Subject: **COLUMBIA GENERATING STATION, DOCKET NO. 50-397
RESPONSE TO REQUEST FOR ADDITIONAL INFORMATION
LICENSE RENEWAL APPLICATION**

**RESPONSE TO REQUEST FOR ADDITIONAL INFORMATION
LICENSE RENEWAL APPLICATION**

RAI B.2.31-1

LICENSE RENEWAL APPLICATION
AMENDMENT 42

Figure 1: Droplet fallout settling on transformer yard

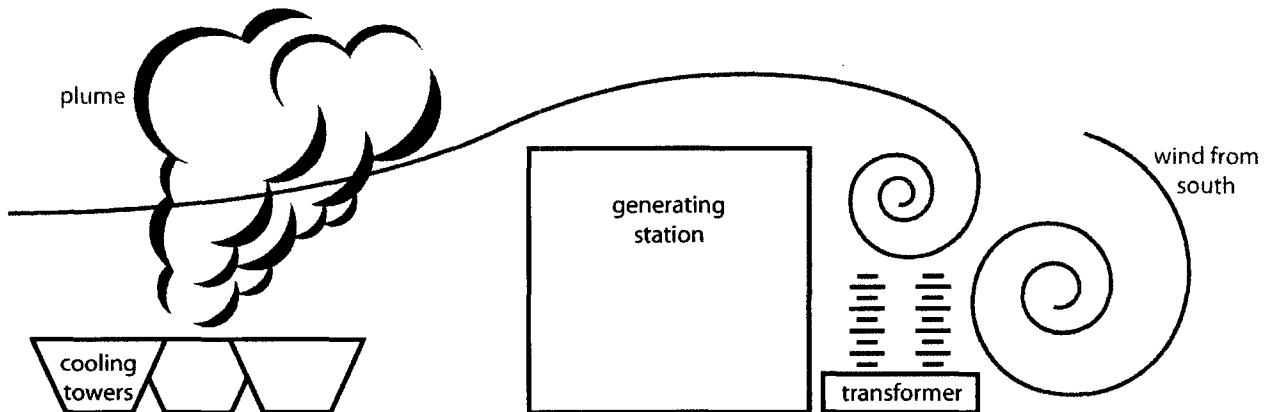
Explain why the high-voltage post insulators at the 230kV ASHE A809 Breaker located in the ASHE Substation are not subject to circulating water system cooling tower spray drift and do not require a coating or cleaning aging management program.

quarter mile north of the main plant. As the drift droplets move northward towards the plant, wind dynamics experienced, as the droplets are carried over the generating station, force much of the droplets down onto the transformer yard, thus making this area the most vulnerable to scintillation. Figure 1 illustrates the effect.

Under worst-case conditions, the drifting droplets created conditions conducive to arcing in the station's transformer yard. This arcing occurred when a sufficient layer of conductive substances built up on the insulators, became wetted, and formed an electrical track. Columbia Generating Station collects its cooling water from the Columbia River, which it then buffers with various chemicals to temper the water for use in the plant. Thus, the substances found in the drift droplets of the cooling tower are chemical species found naturally in the river, those added to buffer the water, those that form from decomposition of original buffers, and trace minerals and metals from the cooling system. The result is a layer of anions and cations that once settled on the surface of insulators present a prime opportunity for insulator failure.

Based on the above, the 230 kV station post insulators at Ashe were not included in the High-Voltage Porcelain Insulators Aging Management Program.
